## Document G701™ – 2001

### Change Order

| <b>PROJECT</b> <i>(Name and address):</i><br>North Hardin High School Renovation<br>North Hardin High School<br>801 S. Logsdon Parkway<br>Radcliff, Kentucky 40160 | <b>CHANGE ORDER NUMBER:</b> 002<br><b>DATE:</b> July 21, 2015   | <b>OWNER:</b> <input checked="" type="checkbox"/><br><b>ARCHITECT:</b> <input checked="" type="checkbox"/><br><b>CONTRACTOR:</b> <input checked="" type="checkbox"/><br><b>FIELD:</b> <input type="checkbox"/> |

**Itemization of Change Order #2**

### SU1.00C PARTIAL SITE UTILITY PLAN - PLUMBING

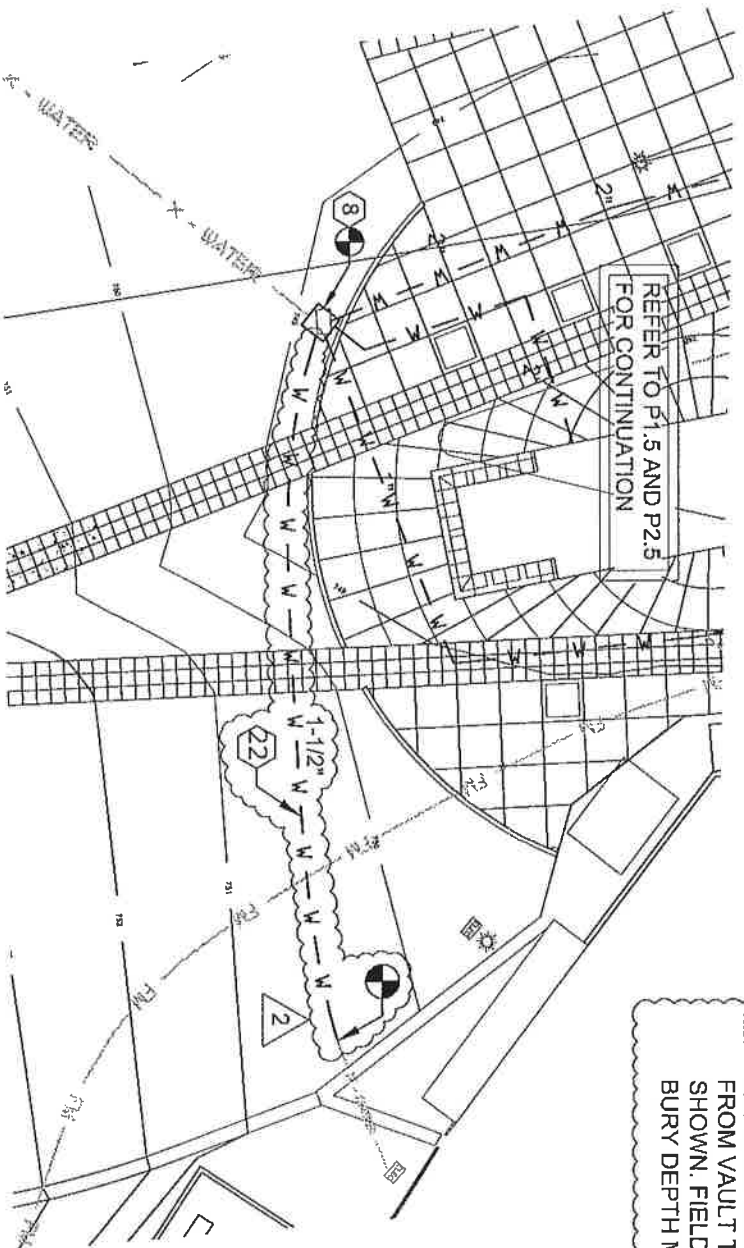
See attached RFI 22 from GBMC regarding cover over water lines at new grade areas.

Upon excavation in the area of the new Concessions Stand, we have discovered that the 1 1/2" domestic water line feeding the baseball field valve box as well as a portion of 3/4" domestic water feeding towards the baseball field will only be ~1' deep when the new grades are completed. There are lines that will remain energized year round and portions will be under the new site concrete. Please advise if any action needs to be taken concerning the existing lines.

Refer to attached drawing SU1.0C for irrigation the be lowered with new grade.

- REPLACE EXISTING 1½" CW LINE FROM VAULT TO LOCATION SHOWN. FIELD VERIFY LOCATION. BURY DEPTH MINIMUM 36".

| SK1.0                        |                   |              |                                  |

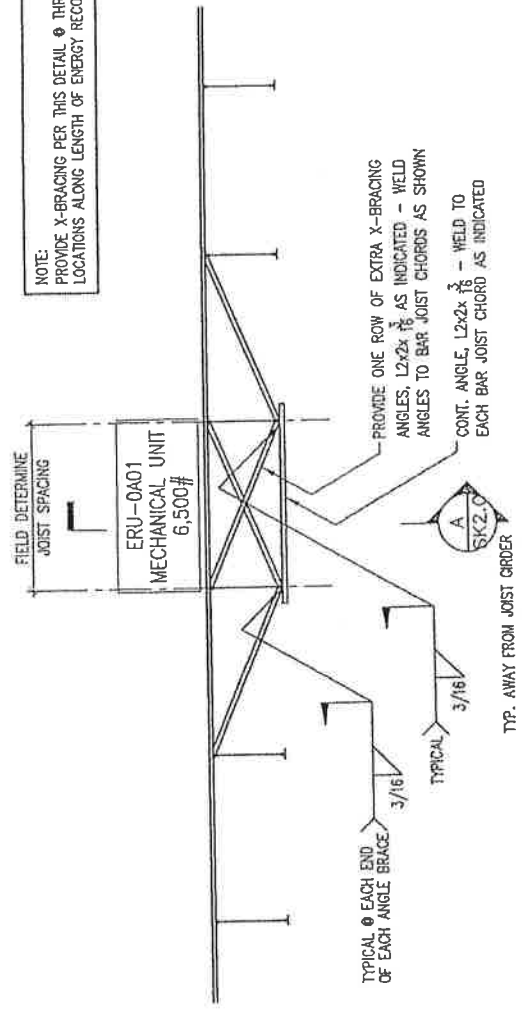
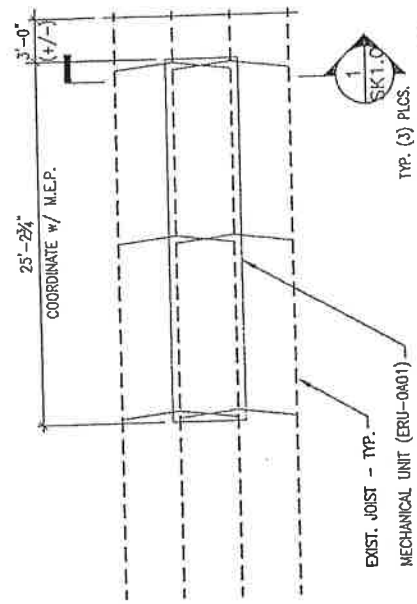
Reinforce roof joists at existing Mechanical Room 319 per Proposal Request 005, Part 2.

- 1) Provide credit proposal to delete painting of large gymnasium ceiling and structure. Contractor shall paint only the new conduit ~~and structure~~.
- 2) Provide cost proposal to reinforce roof joist in existing Mechanical Room 319 to support new roof-top unit. Refer to attached sketches SK1.0 and SK2.0.

NOTE:  
PROVIDE X-BRACING PER THIS DETAIL • THREE (3)  
LOCATIONS ALONG LENGTH OF ENERGY RECOVERY UNIT

P1.5A PARTIAL FIELD HOUSE PLAN - SANITARY SEWER - PLUMBING

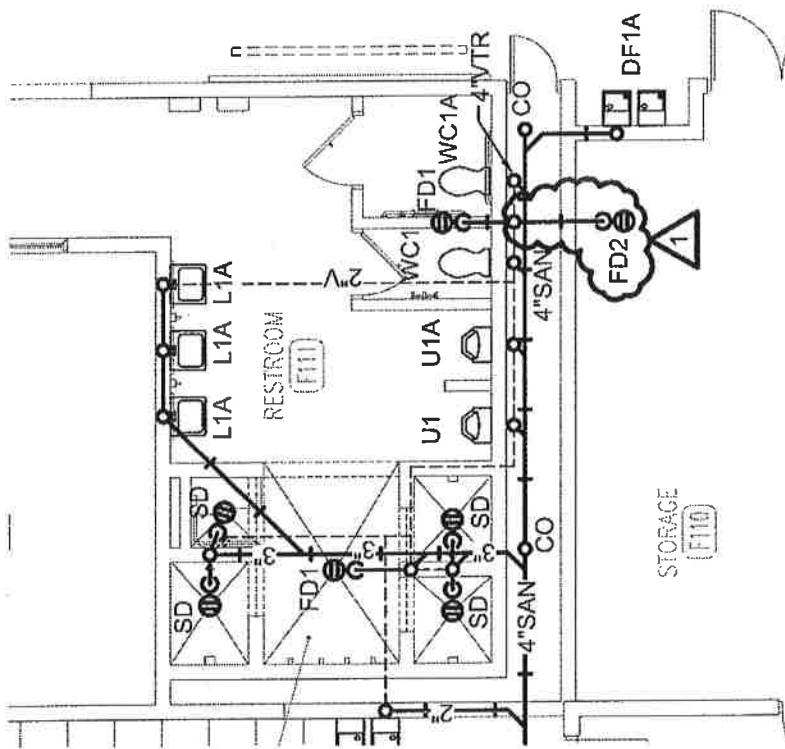
The plumbing drawings do not indicate a floor drain in Storage 110 in the Fieldhouse to receive the condensate for the HVAC units located therein. There are currently open ditches in the area which can receive an added drain if desired. Please advise.

THE PLUMBING DRAWINGS DO NOT INDICATE A FLOOR DRAIN IN STORAGE 110 IN THE FIELDHOUSE TO RECEIVE THE CONDENSATE

See attached drawing with new floor drain FD2 shown. Locate floor drain between HVAC units.

P2.3E PARTIAL CONCESSION STAND PLAN - DOMESTIC WATER - PLUMBING

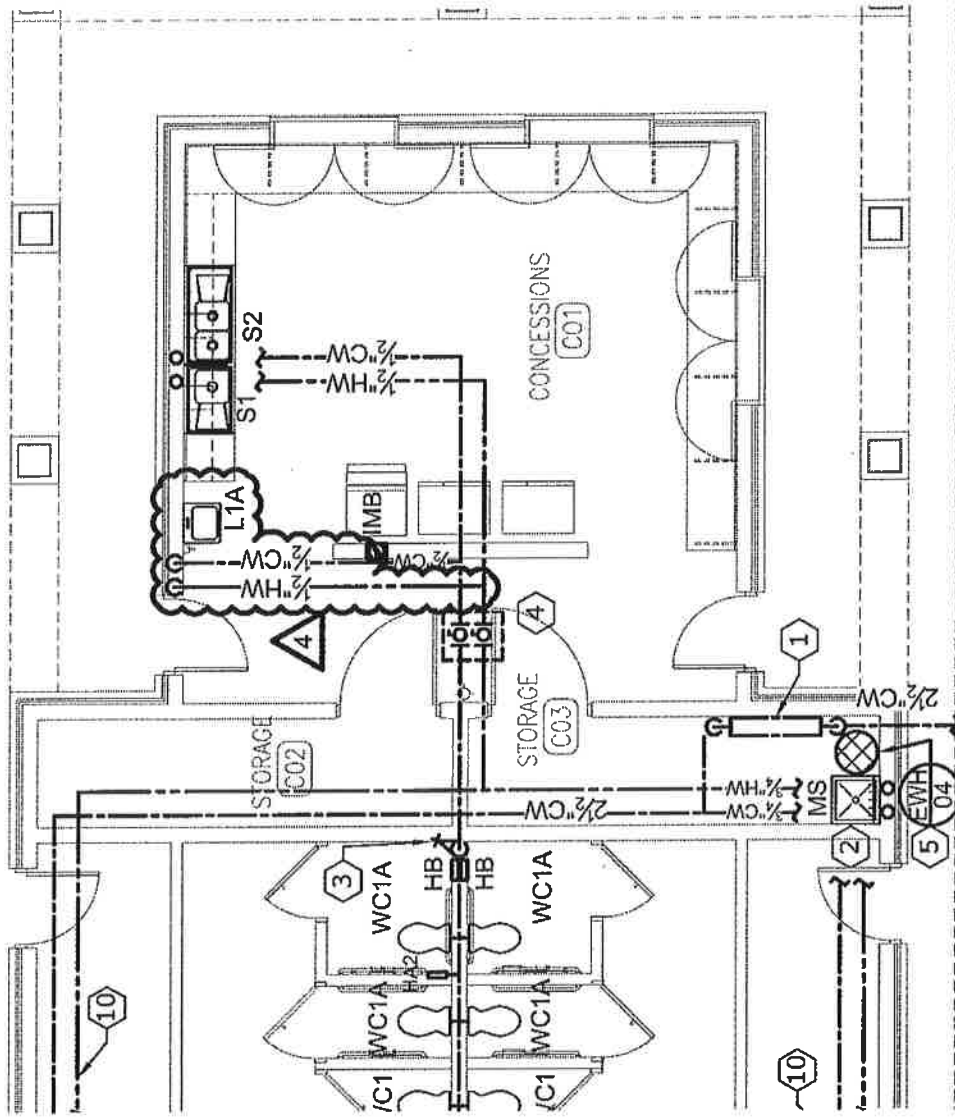
THERE IS AN OUTLINE OF A LAVATORY SHOWN ON THE PLUMBING DRAWINGS IN CONCESSIONS C01 TO THE LEFT OF THE THREE  
COMPARTMENT SINK. THIS DOES NOT APPEAR ON THE RISER DIAGRAM FOR THE WASTE OR WATER. PLEASE ADVISE IF THIS  
LAVATORY NEEDS TO BE ADDED.

Add a Lavatory in Concessions per response to RFI 24

P2.3C PARTIAL FIELDHOUSE PLAN - DOMESTIC WATER - PLUMBING

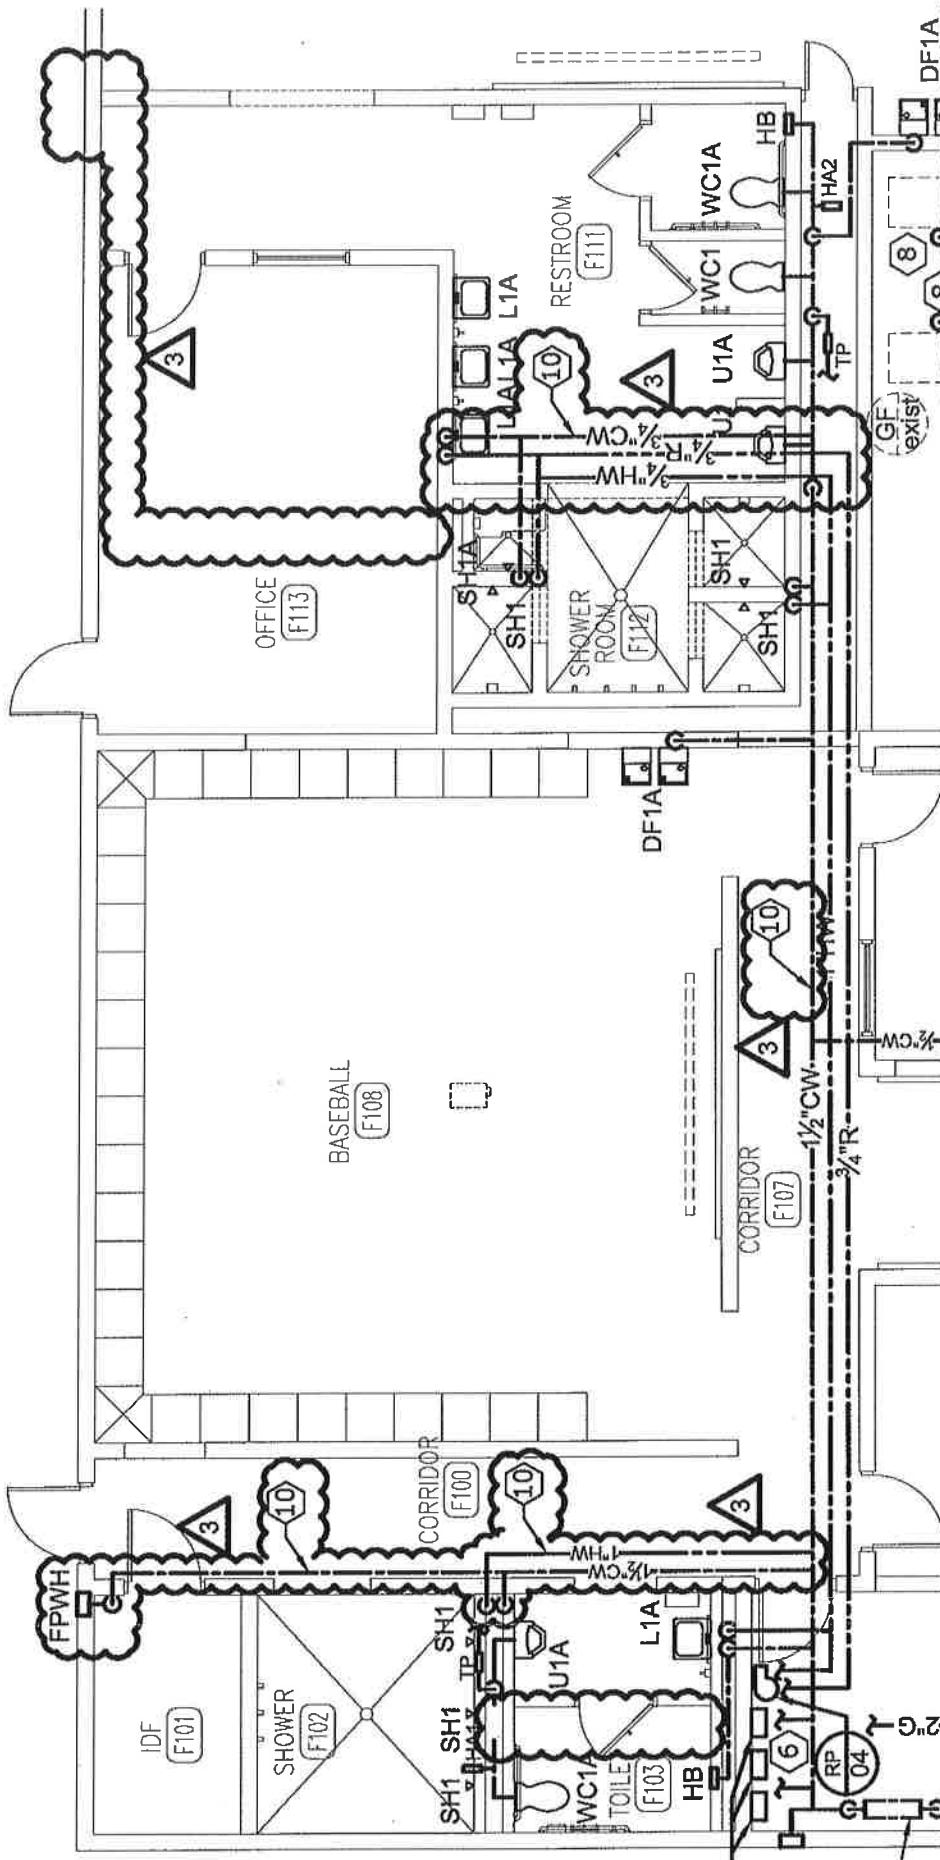
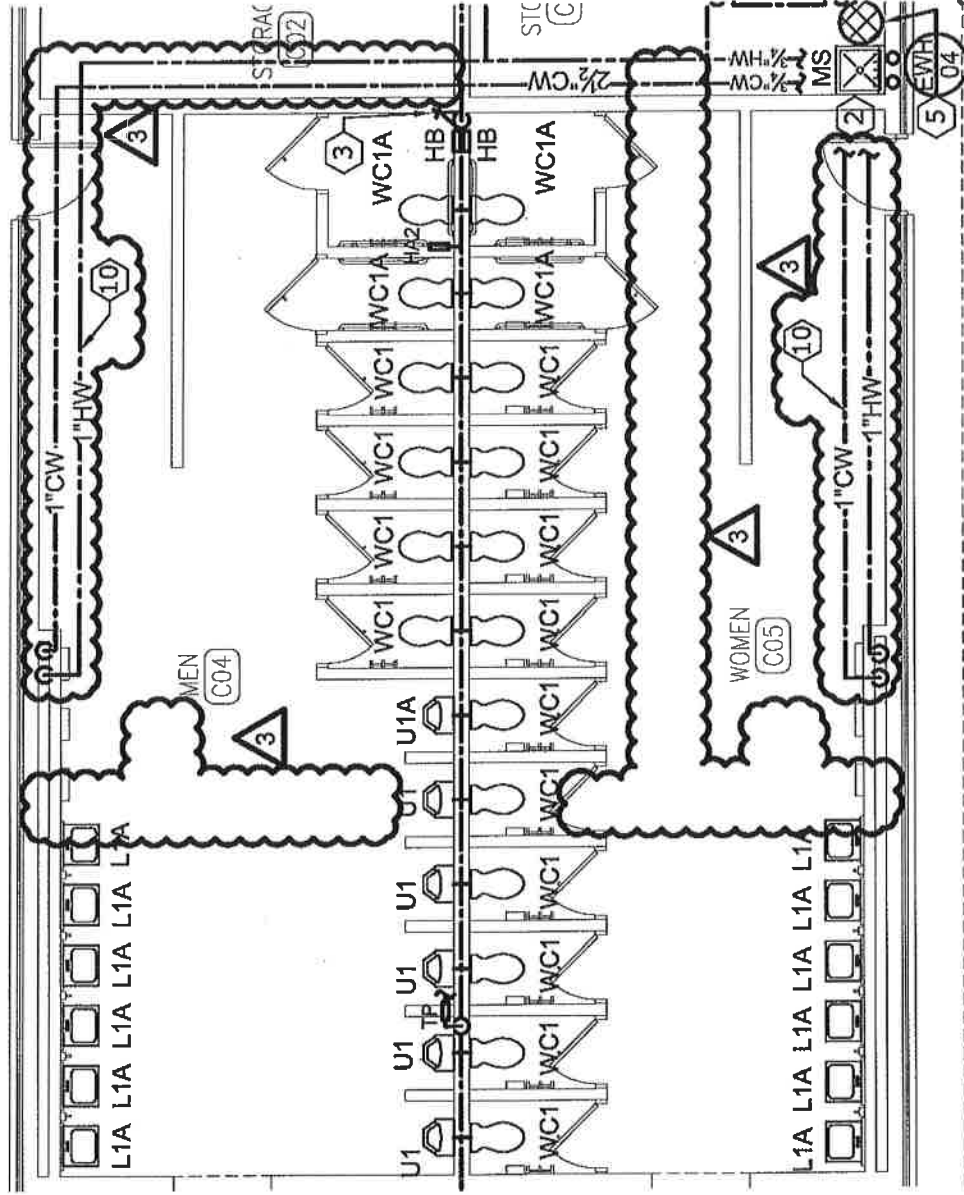
Provide grilles in Fieldhouse soffit per ASI #3
